Rezoning Application: PD 24-0579
Zoning Hearing Master Date: August 19, 2024
BOCC Hearing Meeting Date: October 8, 2024

PETITION NO: PD RZ 24-0579

APPLICATION NUMBER: PD 24-0579

2.4 Proposed Site Plan (partial provided below for size and orientation purposes. See Section 8.0 for full site plan)

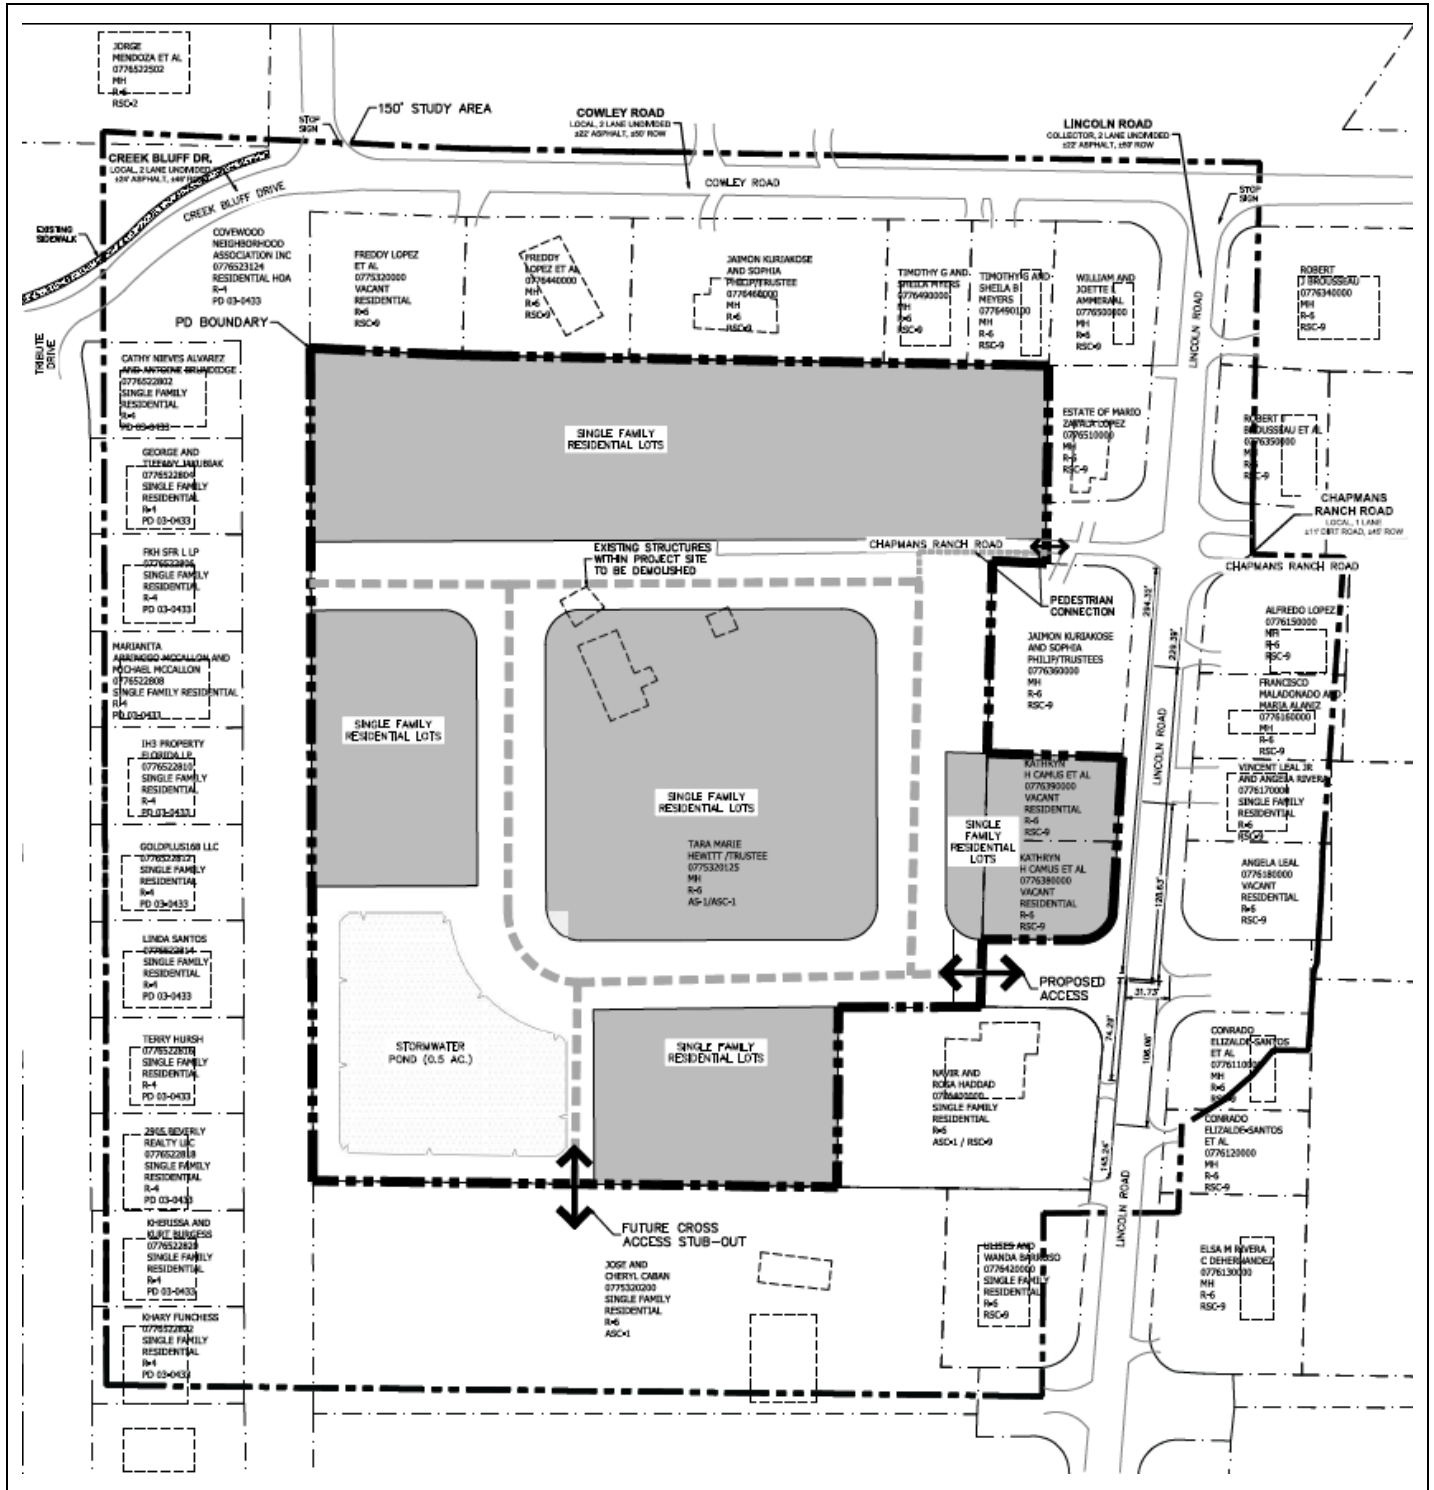
Prior to PD site plan certification, the developer shall revise the PD site plan to:

1. Add a note on the site plan that reads "Sidewalks to be provided per the LDC."
